A D D E N D U M N O. 1

November 30, 2016

**Project: PROPOSED STATION ROAD CULVERT REPLACEMENT PROJECT (#2016-29)
VILLAGE OF IRVINGTON
WESTCHESTER COUNTY, NEW YORK**

ORIGIN OF MAP
 VILLAGE OF IRVINGTON SEWER SYSTEM MAP
 PREPARED BY PAUL J. PETRETTI
 DATED 7/16/04

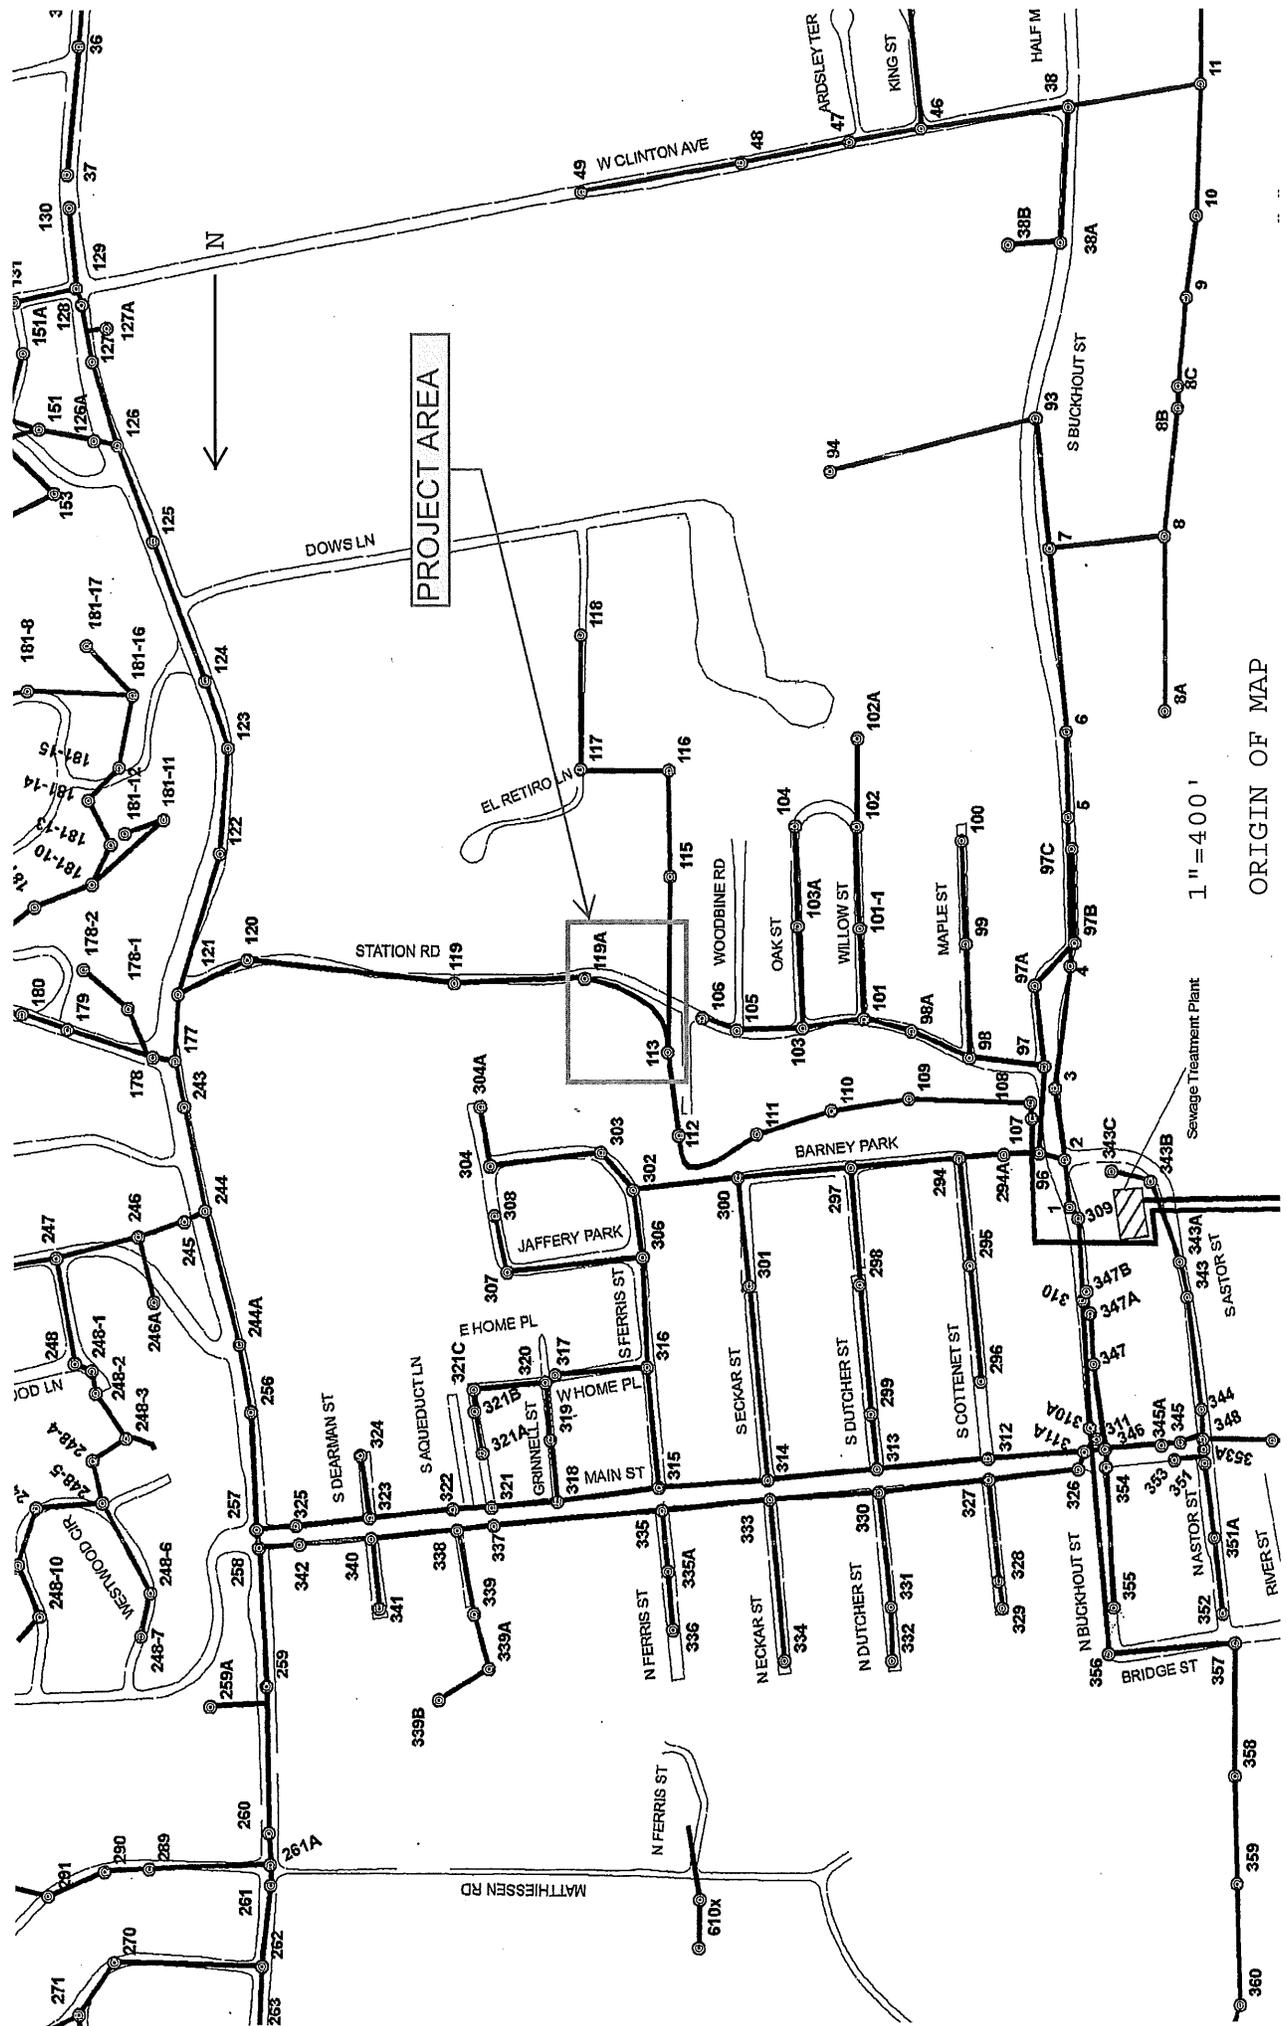
2) Can you provide further details on requirements for sanitary sewer bypass, temporary water, and stream diversion. (Size, type of pipe, etc.)

The sewage should be pumped from the upstream manholes to the lower manholes. Due to the layout of the existing system, the installation of the sewer will be constructed in various stages. The proposed sewer manhole #1 (SMH#1) will be installed between the Village manholes numbers 113 and 115 (see attached Village Sewer Map). The section of pipe will be bypassed while SMH#1 is being installed. Once this is complete, the section of pipe between SMH#1 and manhole 113 will be installed. Then the section of pipe from Village manholes 119A to 113 will be replaced. The Contractor is responsible to provide power to the pump. A spare pump and backup power shall be kept onsite if the main pump fails.
